**Review and Evaluation of Characterization Data Provided
for Safety Light Corporation, Bloomsburg, Pennsylvania**

Eric Pogue
U.S. NRC

ICF Consulting

October 30, 2001

Figure 18

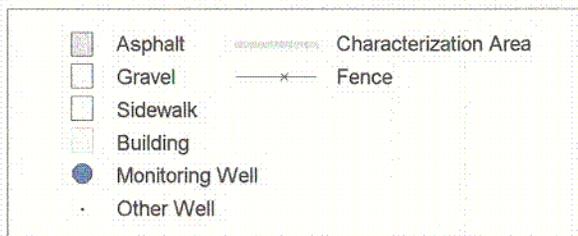
Isotopic concentrations detected above NRC guidelines are presented in Figure 18 in Appendix 1. However, these results presented in the Monserco Site Characterization Report are misleading. The radiological limits for groundwater given in the Monserco Characterization plan are provided in Table 3 in Section 3.2. The detection limits listed in Appendix 17 of the Monserco Characterization Report for Sr-90, Co-60, Cs-137, and Ra-226 are significantly higher than these radiological limits. No radiological limits were provided for Bi-214, Pb-214, and Am-241. Consequently, the non-detects cannot be used to show that the groundwater is not contaminated with these isotopes.
